Origination Form Proposed Revisions to a Standard Plans Index

Originator:	Turley, Joshua	Index Number:	649-031
Date:	2/6/2024	Sheet Number(s):	2 and 6
E-mail:	Joshua.Turley@dot.state.fl.us	Index Title:	Mast Arm Assemblies

2 of 6

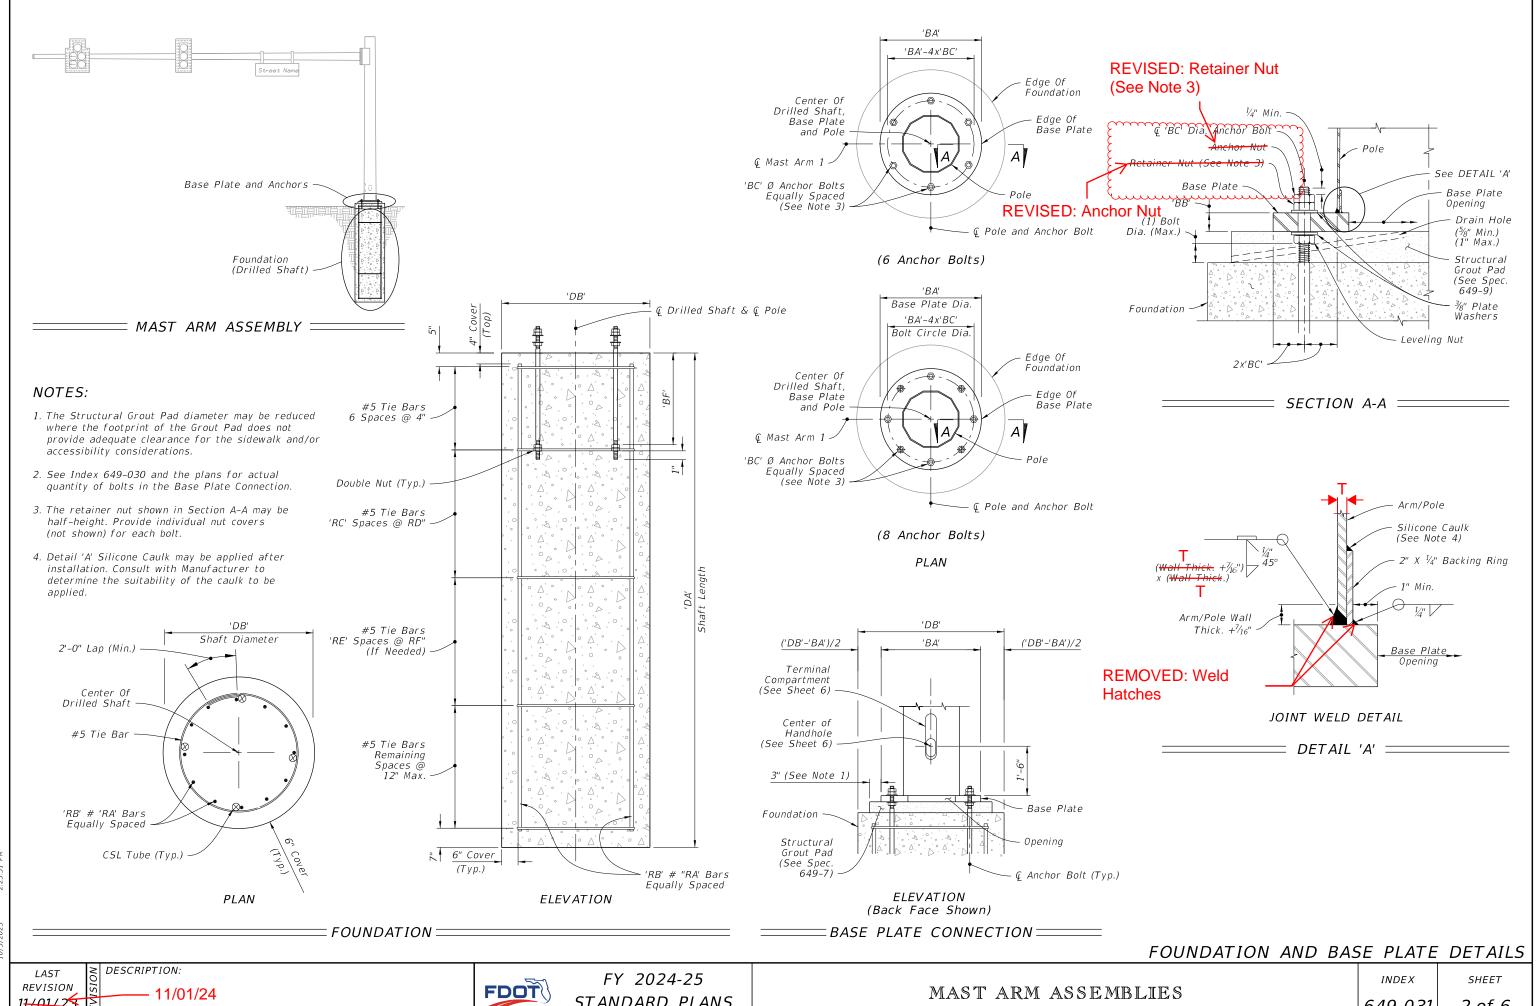
Sheet 2: Section A-A -- Corrected the label order of the anchor nut bolts. DETAIL "A" -- Removed welding hatches, Modified wall thickness from text to symbol.

Sheet 2: Section A-A__ There is an associated Spec change being drafted for Section 649 that pertains to process for tightening the anchor bolts. These changes make it so that the language aligns between the Spec and the Standard.

Sheet 2 and 6: Removing weld hatches to make consistent ith the rest of the Standards and also industry convention.
